# Bobcat/Bunton Service Bulletin

Bulletin No: C-045-05

## 3-Bag Collection System

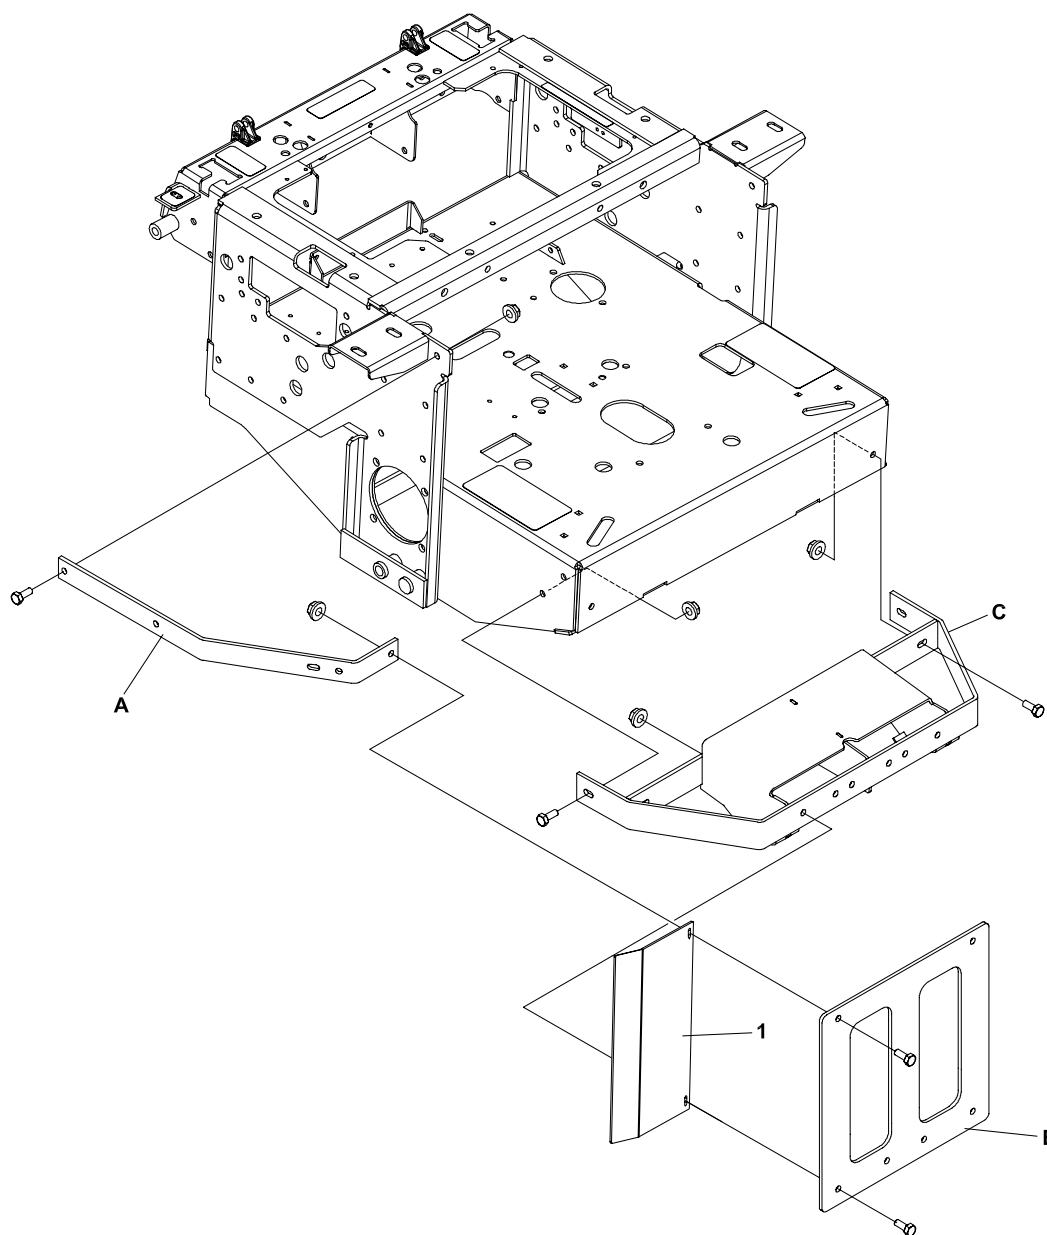
We have received reports of the bag coming in contact with the exhaust system of the engine.

Install muffler guard kit, part number 970336. Refer to attached Instruction Sheet for details.

1. Attach the muffler guard plate **1** between bumper arm **A**, plate **B** and bumper **C** as shown, using existing hardware. Tighten all fasteners at this time.
